**JACOBS****Site Technical Query - Form**

TQ Number:		Project:	
CW2148472	-A010- 0127	Oyu Tolgoi Underground Project	
A. To be completed by or on behalf of the Contractor			
Contractor/Sub-Contractor Name:	MCS International	Date Response	07/10/2022
Contract Title:	Haulage Truck Workshop /C-004D/	Plant Area &	1883
Contract No.	CW2148472	Contractor TQ Number:	TWS-0415-TQ-0127
Discipline Codes (Mandatory) D1 (CSA) - <input type="checkbox"/> D2 (MP) - <input checked="" type="checkbox"/> D3 (E&I) - <input type="checkbox"/> D4 (Other) - <input type="checkbox"/>			
<i>Description of Technical Query (List affected drawings and specifications):</i> LV parking: Pipe clashed with existing cables			
<p>Electrical cables are installed in LV parking area. Also, 1693ICT2001-F02 cable will be installed on this area as per 1883-05-TQS-8219 _0. 1883-AP-2019-C1A-001", 1883-WP-2207-C1A-002" and 1883-WP-2336-C1A-002" pipes are clashed with existing cables.</p>

OYU TOLGOI UNDERGROUND PROJECT

TRUCK SHOP HAULAGE LEVEL GENERAL ARRANGEMENT PLAN

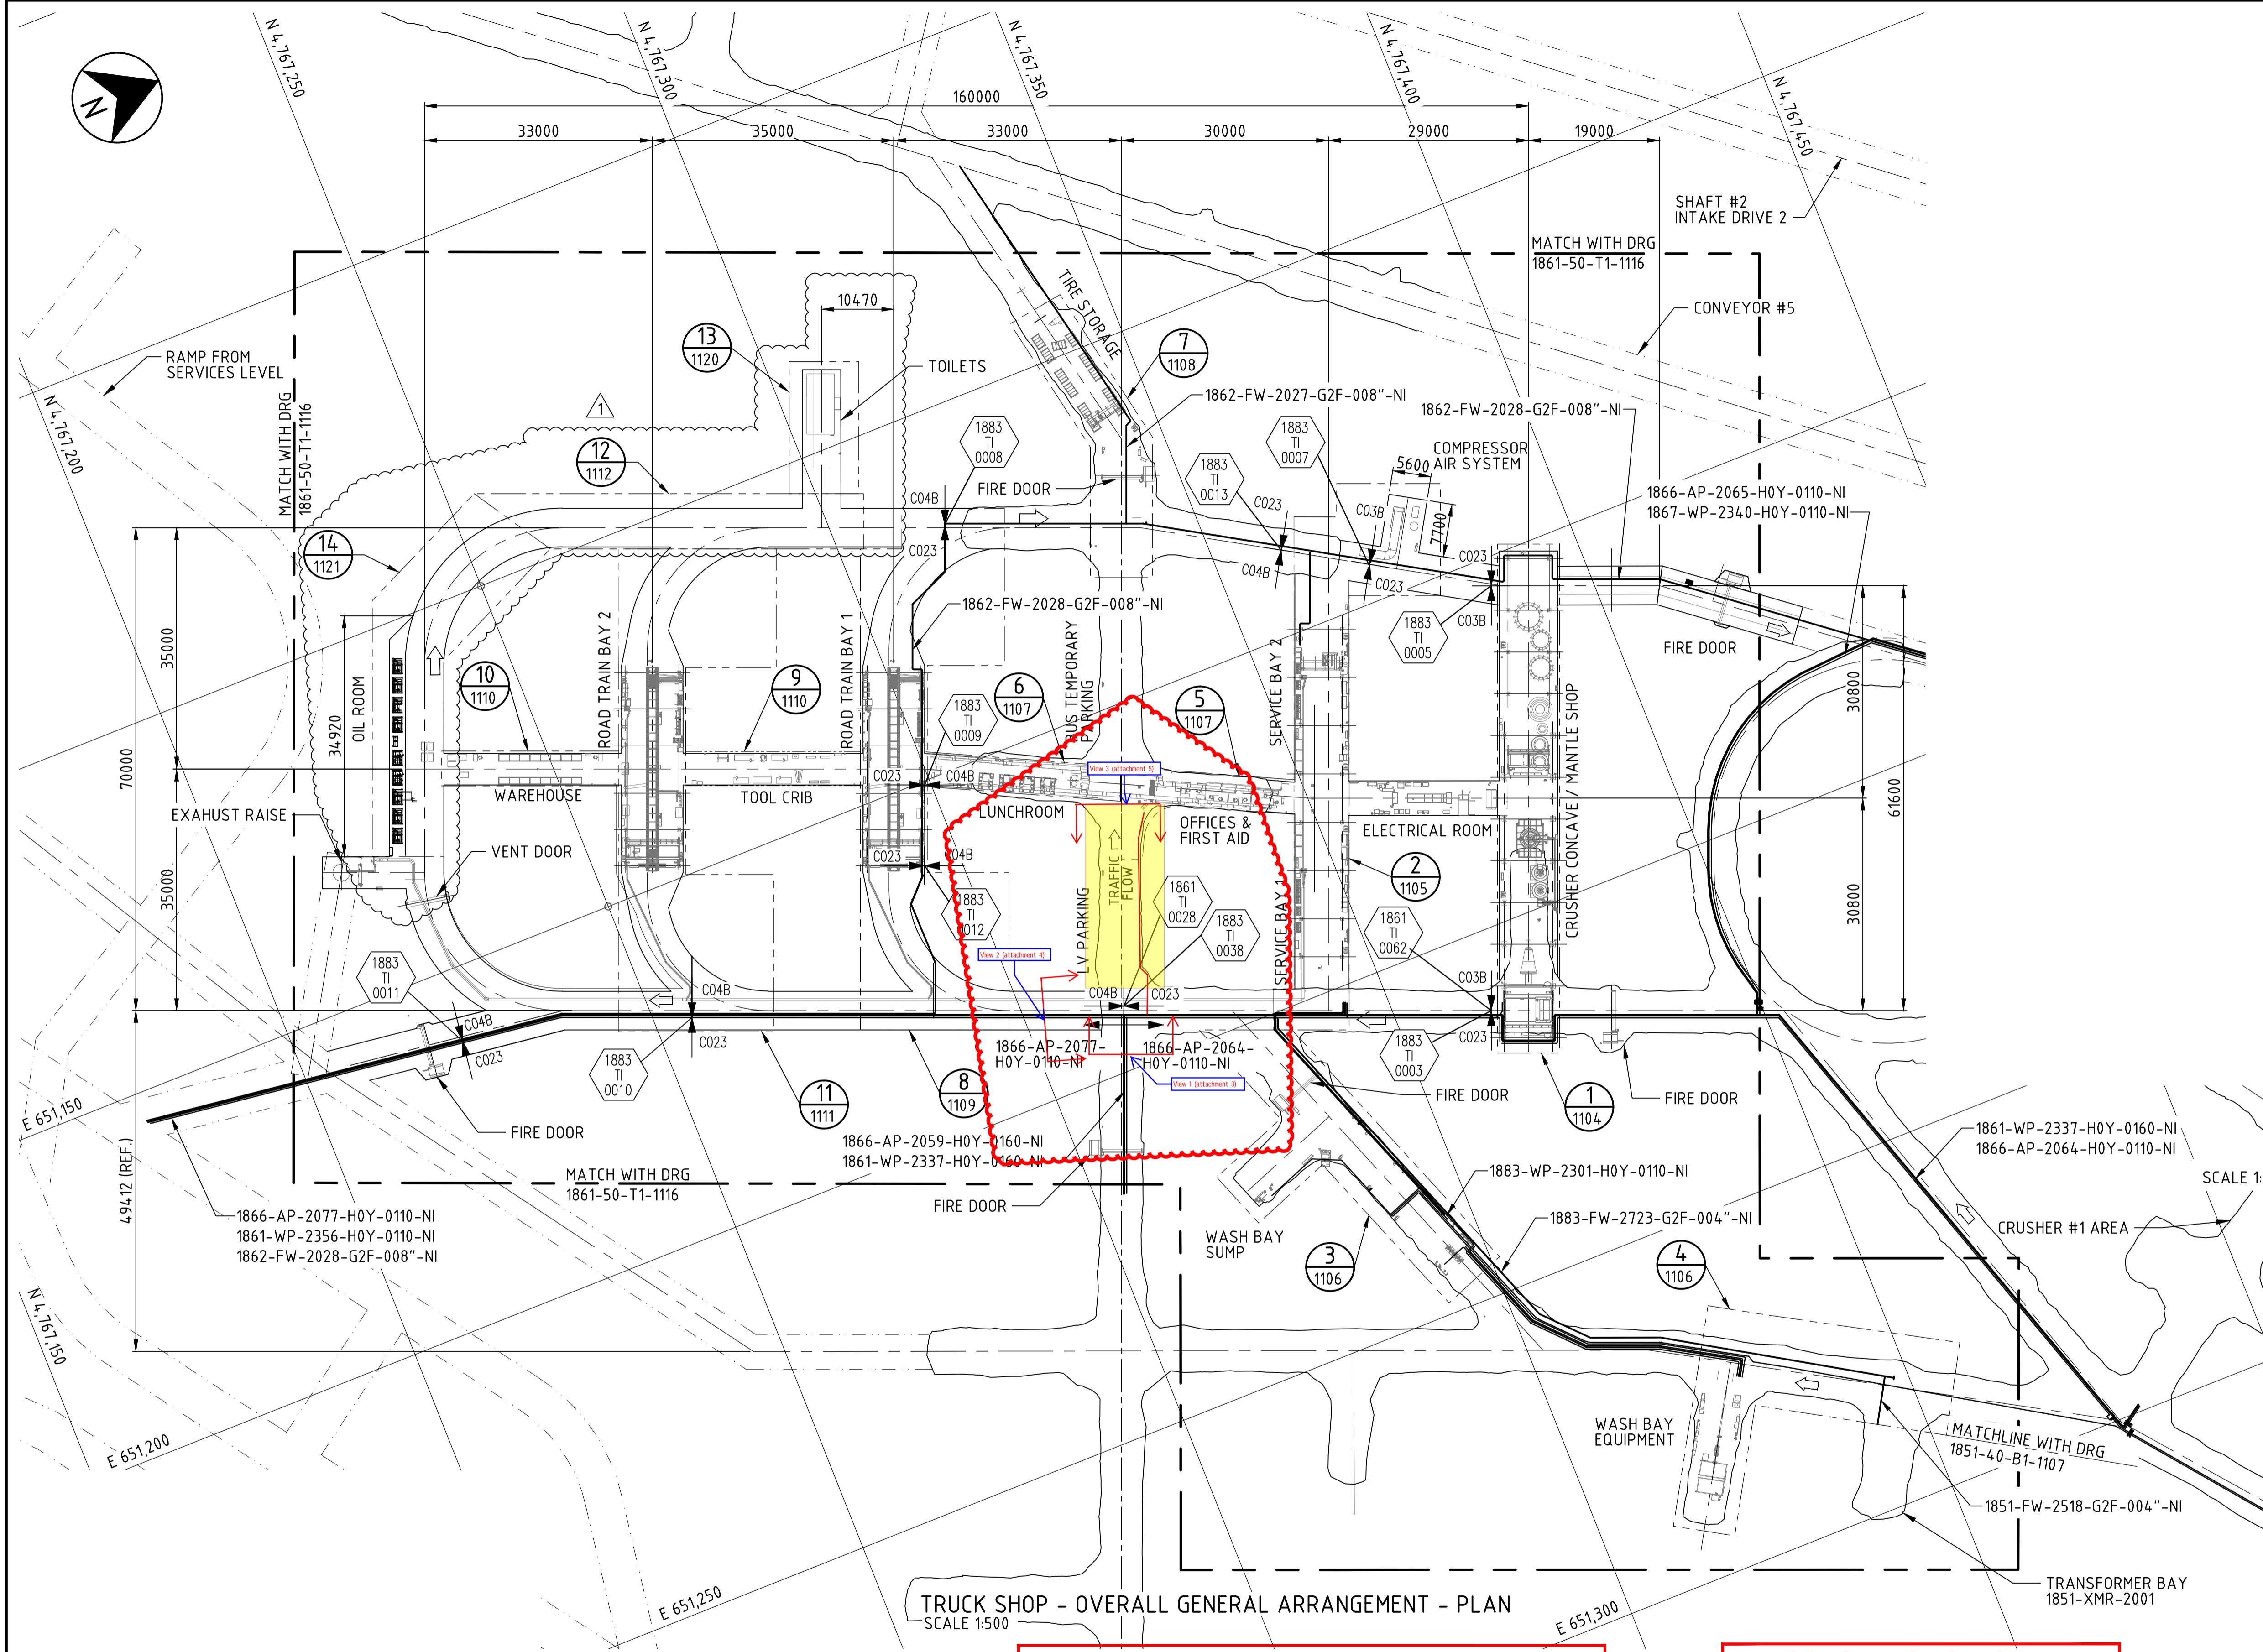
<input type="checkbox"/> Routine		<input checked="" type="checkbox"/> Urgent	Refer Technical Query instructions
<i>Proposed Action (List all attachments)</i>			
<p>Therefore, the contractor proposes following actions.</p> <ol style="list-style-type: none">1. Change the 1883-AP-2019-C1A-001", 1883-WP-2207-C1A-002" and 1883-WP-2336-C1A-002" pipes route as attachment 2. Attached the field photos (attachment 3, 4, 5).2. Change the support SD-101 to SD-103, Pipes are supported on wall by SD-103 (attachment 2).3. Change the rock bolt of only one marked orange support (SD-101) in attachment 4 to M24 anchor rod. Pull test shall be conducted with 50kN.			
Effect on cost (USD):	NO		
Effect on schedule (Days):	NO		
Effect on quality:	NO		
Requested by (Name):	Delgersuren N.	Position:	SMP Field Engineer
Signature:		Date: (dd/mm/yyyy)	04/10/2022

Attachment 7

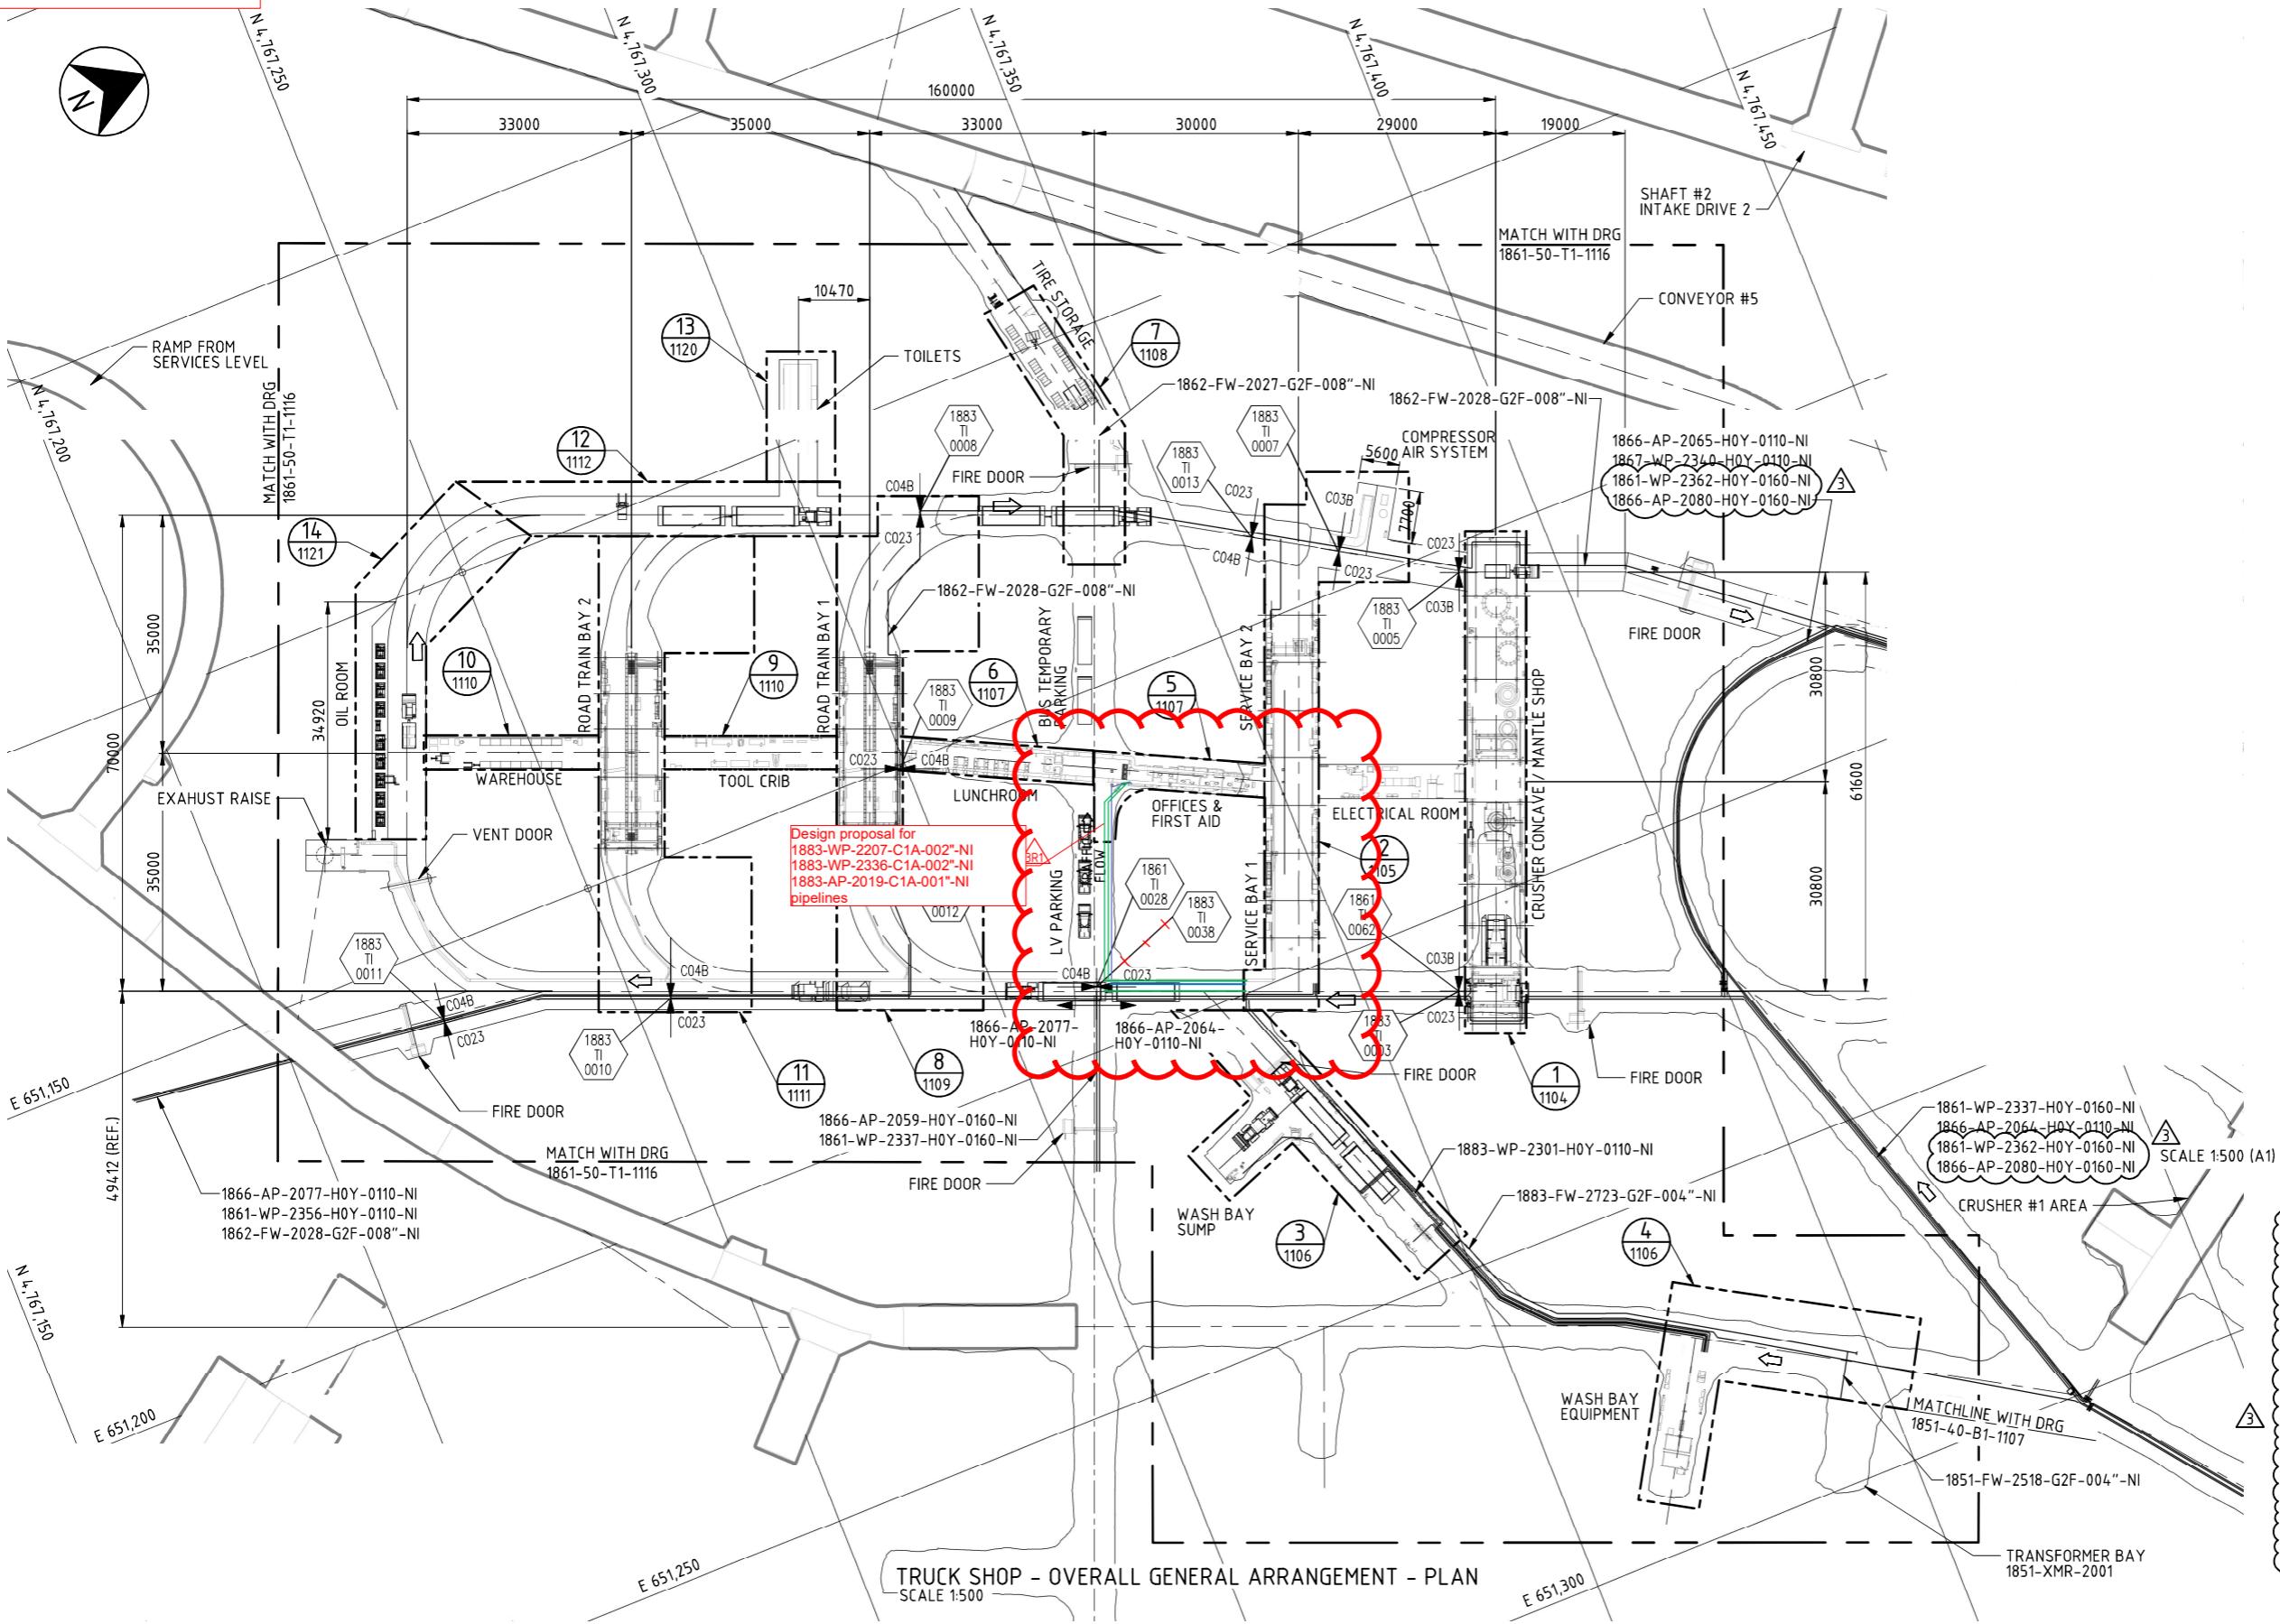
TQ Number:		Project:		
CW2148472	-A010- 0044	Oyu Tolgoi Underground Project		
A. To be completed by or on behalf of the Contractor				
Contractor/Sub-Contractor Name:	MCS International	Date Response	16/06/2022	
Contract Title:	Haulage Truck Workshop /C-004D/	Plant Area &	1883	
Contract No.	CW2148472	Contractor TQ Number:	TWS-0415-TQ-0044	
Discipline Codes (Mandatory) D1 (CSA) - <input type="checkbox"/> D2 (MP) - <input checked="" type="checkbox"/> D3 (E&I) - <input type="checkbox"/> D4 (Other) - <input type="checkbox"/>				
<i>Description of Technical Query (List affected drawings and specifications):</i> Design proposal for 1883-WP-2336-C1A-002"-NI, 1883-WP-2207-C1A-002"-NI, and 1883-AP-2019-C1A-001"-NI lines				
<ol style="list-style-type: none"> The 1883-WP-2207-C1A-002"-NI, 1883-WP-2336-C1A-002"-NI and 1883-AP-2019-C1A-001"-NI pipelines marked on the P&ID drawings of 1883-25-J1-1113_4, 1883-25-J1-1115_2BL, and 1883-25-J1-1121_0. According to the scope, the plan drawings and layout for piping sizes less than 3" are detailed by contractor. Therefore, contractor has checked pipe route and clash from sections of 1 to 6, including pipe support design for LV parking area.

<input type="checkbox"/> Routine		<input checked="" type="checkbox"/> Urgent	Refer Technical Query instructions	
Proposed Action (List all attachments) <ol style="list-style-type: none"> The contractor proposes to design SD-101 pipe supports for 1883-WP-2207-C1A-002"-NI, 1883-WP-2336-C1A-002"-NI and 1883-AP-2019-C1A-001"-NI pipelines. Also, the pipe routes were planned by 3D model as shown in attachments of 2,3 and 4. 				
Attachments: <ol style="list-style-type: none"> Appendix 1. Appendix 2. Appendix 3. Appendix 4. 				
Effect on cost (USD):	NO			
Effect on schedule (Days):	NO			
Effect on quality:	NO			
Requested by (Name):	Zoljargal N.	Position:	MP Field Engineer	
Signature:	Zoljargal Narankhishig	<small>Digital signature by Zoljargal Narankhishig DN: Oyu-MCSI_O=TWG, CN=Zoljargal Narankhishig, E=zoljargal.narankhishig@mcsi.mn Request ID: 1883-05-TQS-8144_0 Location: your signing location here Date: 2022-06-13 14:29:43 Foxit PhantomPDF Version: 10.0.1</small>	Date: <i>(dd/mm/yyyy)</i>	06/13/2022

Proposed action is accepted with following comments:

1. The contractor shall keep pipe clearances in between pipelines(specially on section#6)
2. The contractor shall include field photos of existing services and supports for further submission.
3. Selected option(supports & pipe arrangements) shall be captured in relevant redline drawings.
